ADDENDUM

ME-01

Project: SCCDSB – St. Elizabeth School –
Boiler Replacement

Date: May 03, 2016

| Drawing No.: M-5R | |

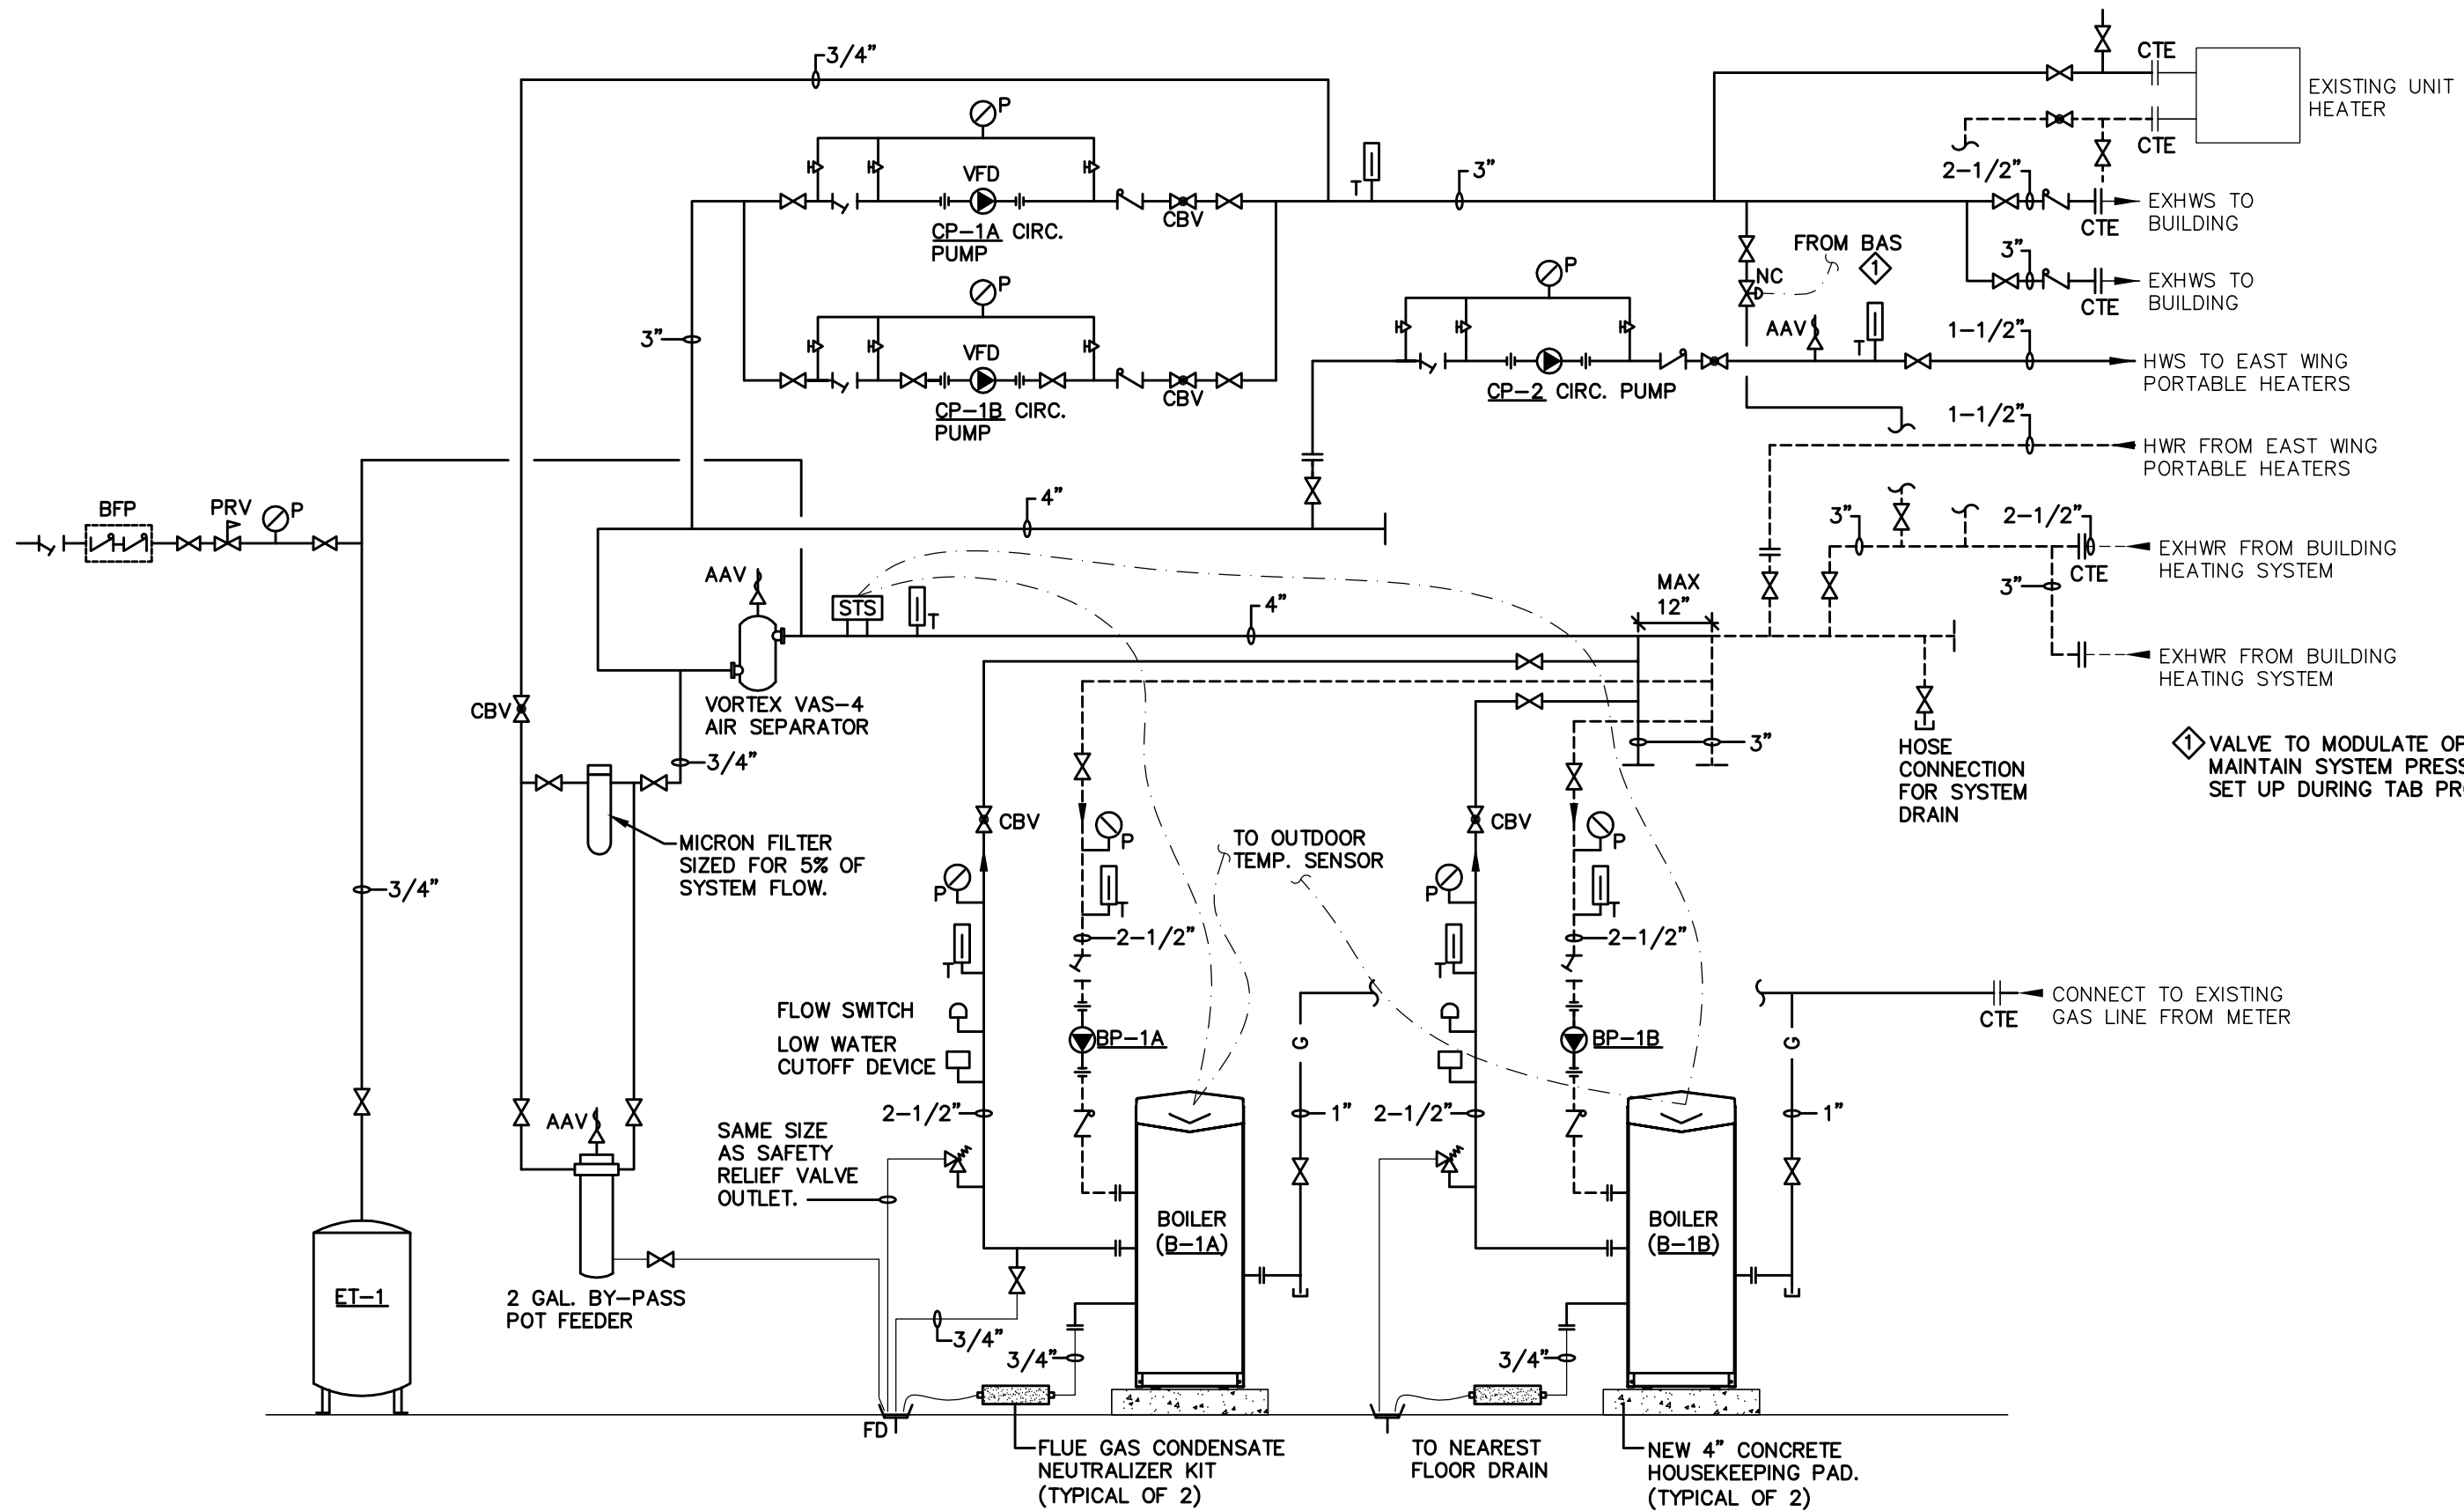
.1 Refer to Drawing No. M-5

.1 Refer to attached sketch M-5R, Boiler room piping schematic; and replace the drawing M-5 with M-5R in its entirety.

Ⓛ VALVE TO MODULATE OPEN TO MAINTAIN SYSTEM PRESSURE AS SET UP DURING TAB PROCESS.
